METROPOLITAN GOVERNMENT OF NASHVILLE AND DAVIDSON COUNTY

STAFF RECOMMENDATION
1329 Seventh Avenue North
November 18, 2015

Application: New construction-infill (Final SP design)
District: Germantown Historic Preservation Zoning Overlay
Council District: 19
Map and Parcel Number: 08112044100
Applicant: Manuel Zeitlin
Project Lead: Melissa Baldock, melissa.baldock@nashville.gov

5 LEVEL 1 PLAN
3/32" = 1'-0"

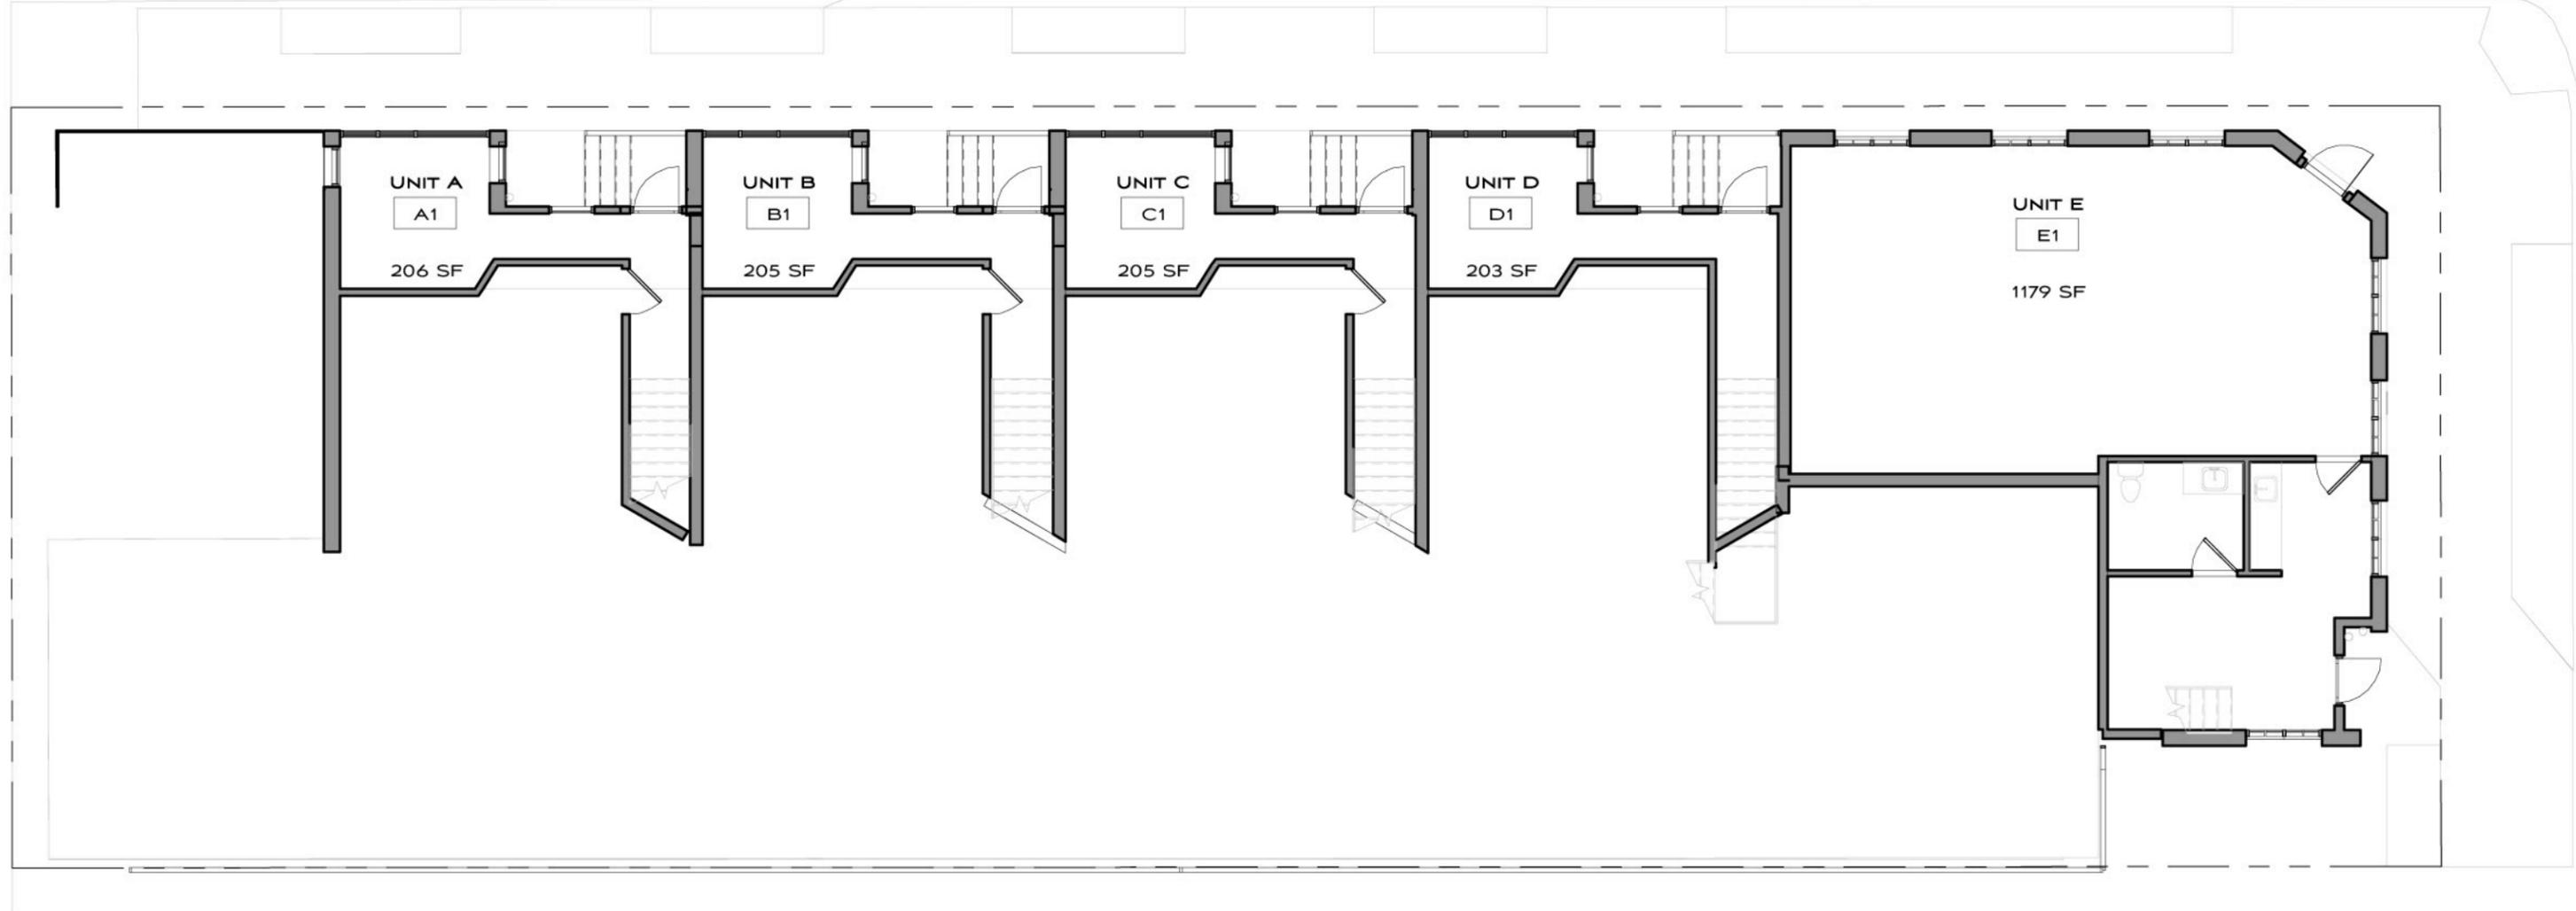
Site Improvements: Since Germantown is an historic preservation overlay, all site improvements, including, but not limited to, fencing/walls, sidewalk changes, exterior lighting, signage, bike racks, and railings, are regulated by MHZC. The submitted plans indicate that a six foot (6') composite board dumpster enclosure will be installed along Taylor Street, between the end of the building and the alley. Along the interior lot line, a six foot (6') tall composite board privacy fence will be installed. Staff finds the heights and locations of these fences to be appropriate, but recommends reviewing a material

sample to determine its appropriateness. Staff also recommends approval of all other permanent site features, including exterior lighting, signage, bike racks, railings, etc. With these conditions, staff finds that the known site improvements meet Section 5.0. of the design guidelines.

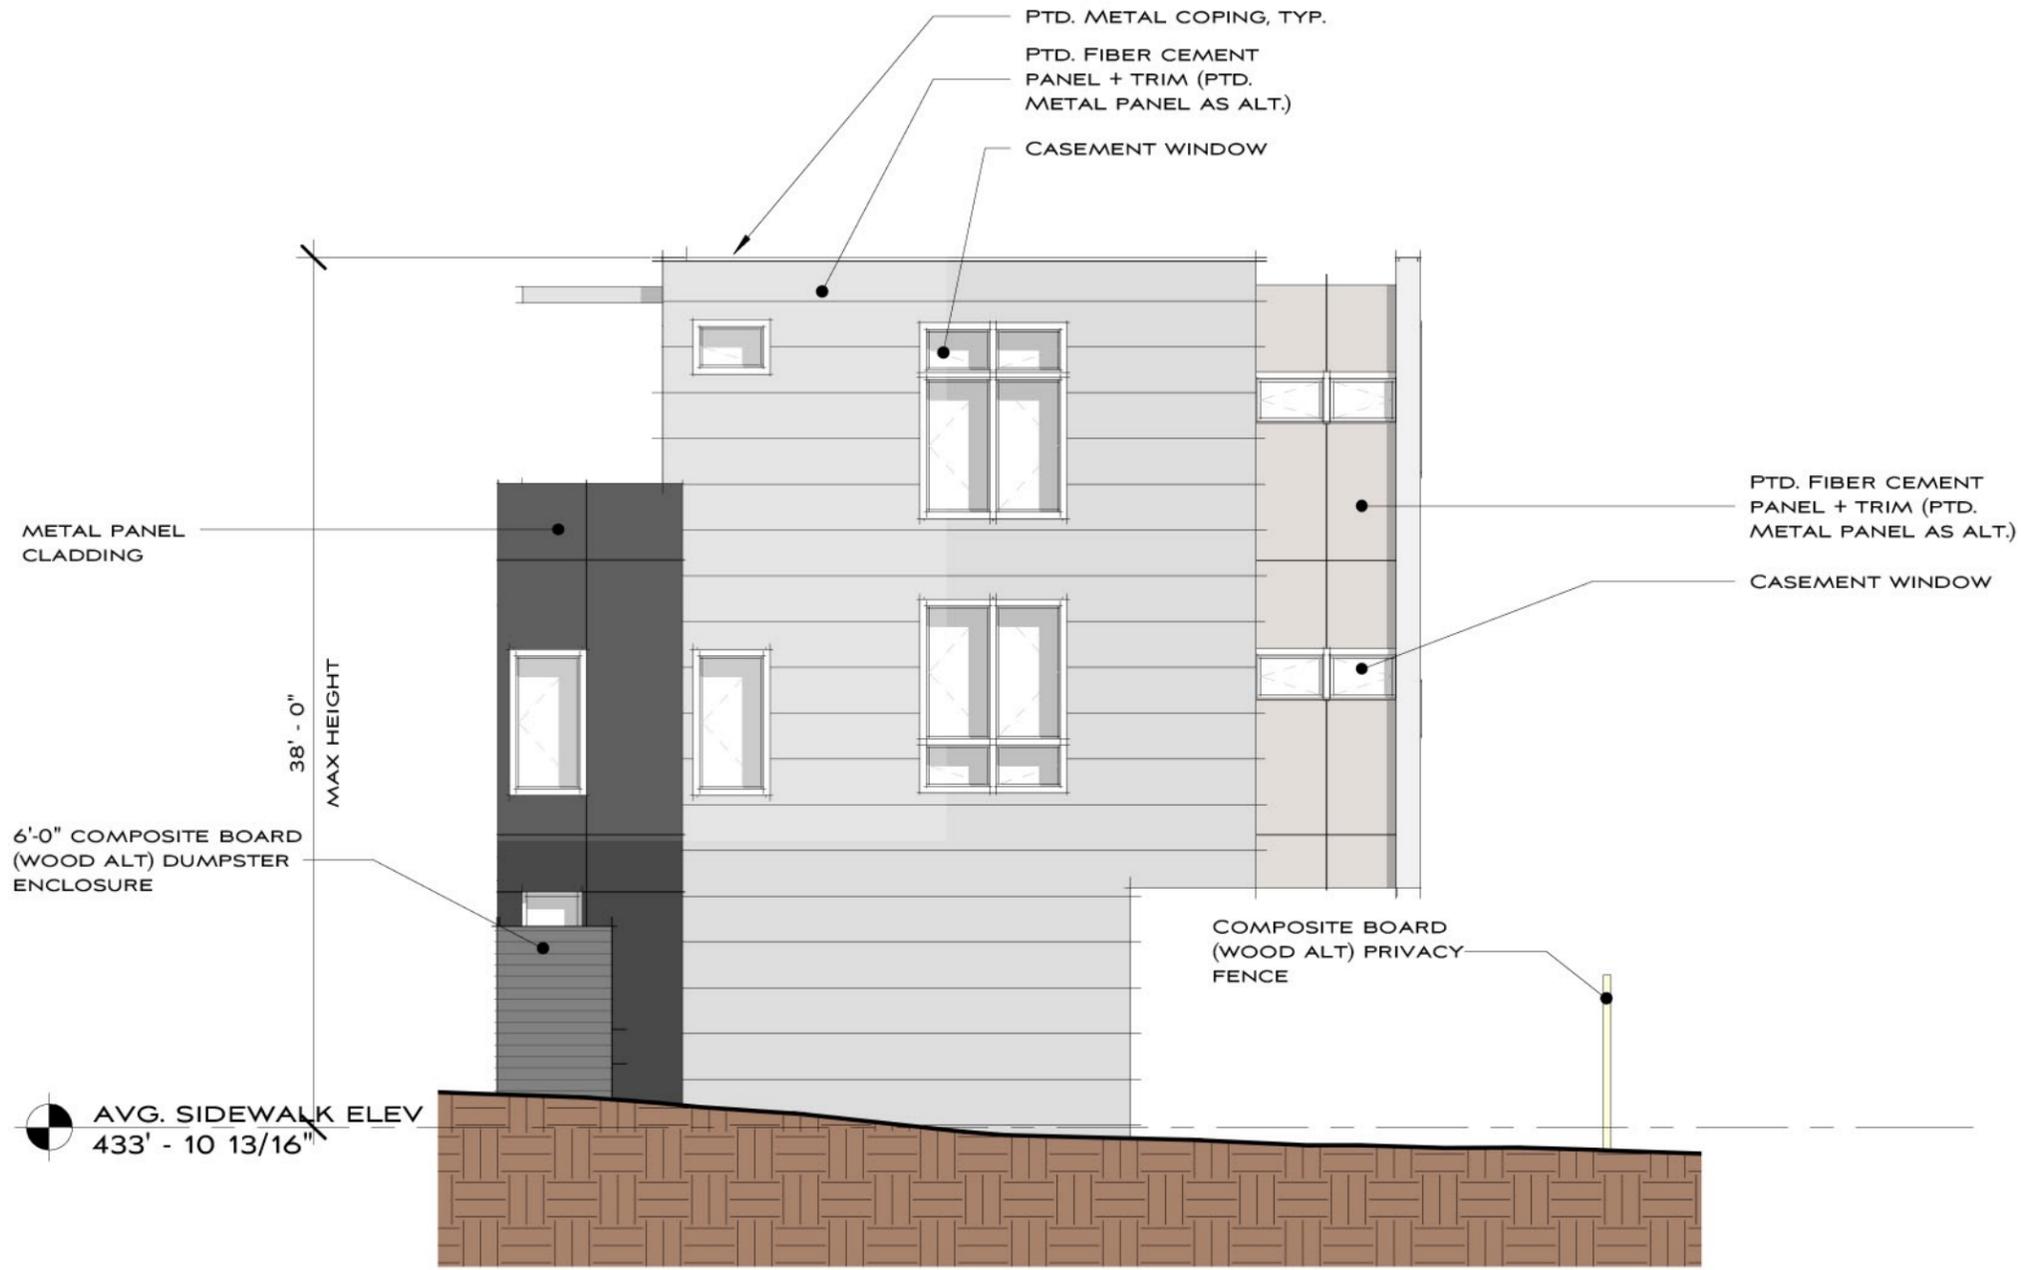
Walls/Exterior Materials The Seventh Avenue façade of the structure will be primarily clad in brick. Staff recommends approval of a brick sample. The recessed upper level will be clad in fiber cement or metal panels, both of which meet the design guidelines, and the projecting bays along Taylor Street will be clad in metal panels. The canopy over the chamfered entry will be metal. Staff recommends approval of all metal colors and texture prior to purchase and installation.

The trim will be cement fiberboard. The development's windows will be aluminum clad or aluminum storefront window, and staff recommends approval of all window and door selections prior to purchase and installation. The materials for the stoop stairs and hand rails were not specified, and staff asks to review these materials and design prior to purchase and installation. The rear and interior lot facades will also be clad in metal panel, fiber cement panel, and brick.

1. Staff approve masonry samples;
2. Staff approve the metal panel color and texture, and the metal for the entry canopy;
3. Staff approve the design and materials of the stoop stairs and stoop railing;
4. Staff approve the final window and door selections prior to purchase and installation;
5. Staff approve a composite board sample for the fencing; and
6. Staff approve all permanent landscape features, including, but not limited to, exterior lighting, signage, bike racks, railings, etc.
